Office Action Summary	Application No. 10/767,177	Applicant(s) CARVER, KEITH R.	
	Examiner Felix O. Figueroa	Art Unit 2833

DETAILED ACTION

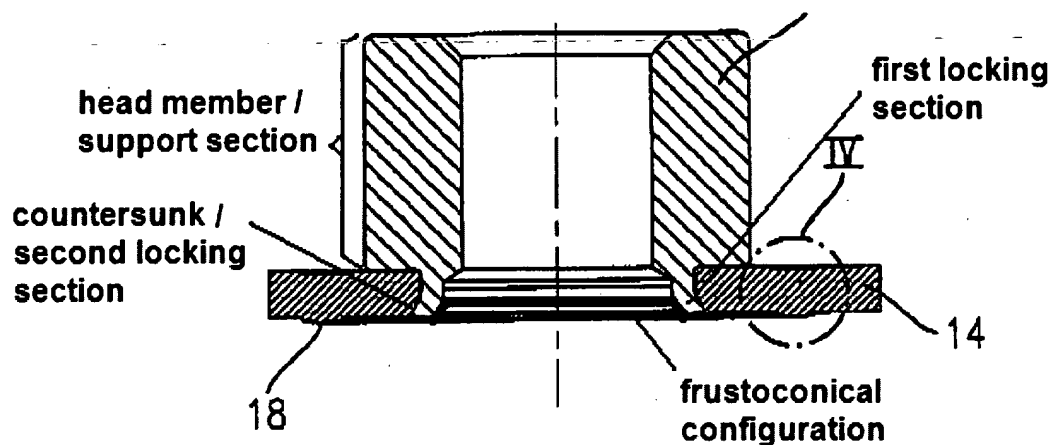
In response to Applicant's argument that Krause further fails to disclose "a distal end of a body portion being swaged radially outward into a frustoconical configuration", please see the following figure.

In response to Applicant's argument regarding claims 4 and 15-18, see the previous figure.
